<b>Location:</b>	<b>1510 Webster Street</b> <b>(See map on reverse)</b>
<b>Assessor's Parcel Numbers:</b>	<b>008-0625-032-00 &amp; -034-01</b>
<b>Proposal:</b>	Construct a 19-story mixed-use building containing 182 dwelling units over ground floor/basement commercial. The proposal includes the use of the Affordable Housing Density Bonus and will include 16 units designated as low income as well as request a concession for minimum required open space.
<b>Applicant:</b>	Colin Nelson / oWOW
<b>Owners:</b>	1510 Webster LLC
<b>Planning Permits Required:</b>	Regular Design Review for new construction Parcel Map Waiver to merge two lots into one
<b>General Plan:</b>	Central Business District
<b>Zoning:</b>	CBD-P & CBD-C / CBD Height Area 6
<b>Environmental Determination:</b>	Determination Pending
<b>Historic Status:</b>	1510 Webster - OCHS Rating: F3
<b>City Council District:</b>	3
<b>For further information:</b>	Contact case planner <b>Pete Vollmann</b> at <b>(510) 238-6167</b> or by email: <a href="mailto:pvollmann@oaklandca.gov">pvollmann@oaklandca.gov</a> .

Staff requests that the Design Review Committee receive public testimony and provide comments on the proposed design.

# CITY OF

# ELEVATIONS

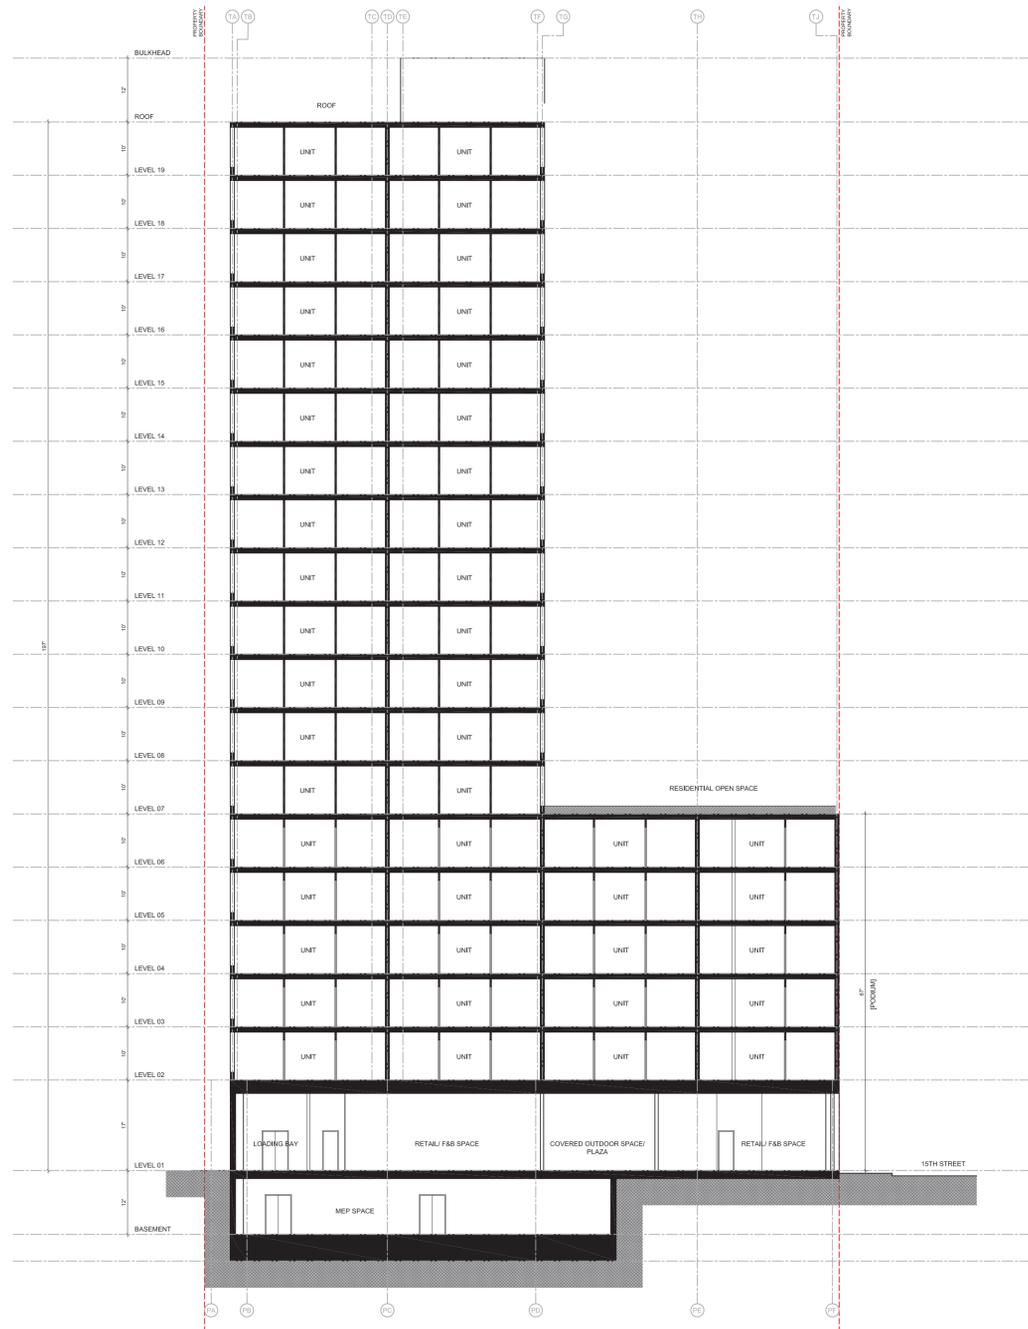
The building base element includes the use of a terracotta rainscreen system articulated with a punched window pattern which relates to older buildings in the area. However, there are a number of locations where those elements of the building’s window pattern appear to accommodate a structural wall and are reflected as solid wall within this pattern. Staff recommends that a different design approach be used for these portions of the elevations as it gives the appearance of sealed windows off or that of a seismically retrofitted building that closed off prior openings.

The ground level of the building along the street frontages consists largely of storefront glazing, which is broken up with concrete piers that would include vertical grooves. Staff has concerns about the concrete piers as they relate to the overall building architecture and would recommend more of a finish material versus the proposal for exposed concrete as it may end up giving an unfinished appearance to the façade. Often board formed concrete is used for ground floor elevations to a building that has a more raw industrial exterior appearance, whereas the proposed building is incorporating a terracotta system for the building base which may not relate as well to the proposed concrete. Staff is open to seeing more detail on the proposed finish pattern, but has concerns about compatibility to the overall design. Additionally, the building is set back from the northern property line, but the ground floor element of the building does not include a finished design treatment to grade and instead includes a blank concrete wall. Staff recommends that a finish material be used in this location due to the visibility of the building from the sidewalk. This side setback also leads to a light well that provides light down to the basement commercial space. Staff further recommends that this space be used as an additional access route to the basement level to provide an additional street connection and to represent an active area versus the closed off side yard currently proposed.

The tower that extends above the building base includes the use of varying color metal panel systems that establish vertical pattern lines to the tower façade and a continuous pattern of aluminum windows. Staff has concerns that the aluminum panel system is creating too strong of a monotonous vertical pattern to the building and would recommend looking at simplifying the elevations by limiting the vertical lines to a few accent locations if at all. The applicant should also look at ways to define the top of the building, even if by simply connecting the visual points vertically of the window openings on the top two floors with a window wall system and a heavier parapet line. In addition, the applicant should look closer at the window mullion pattern of the proposed windows as they currently give the appearance of a retrofit aluminum slider window system that is not compatible with an existing building. Windows for the tower could be similar to those currently proposed on the building base for a consistent window through the building.

An additional issue of the tower façade is that the eastern elevation is located too close to the property line to allow any openings, which results in a 19-story blank wall for the entire elevation articulated only by alternating patterns of metal panel siding. Staff recommends that the applicant set the tower back in order to accommodate openings, or at least recess the midpoint of the elevation that aligns with the internal hall way corridor to provide an opening and then include a façade pattern similar to the overall tower while using spandrel placement in lieu of actual functioning windows to give the appearance of glass windows continuing up the building façade.
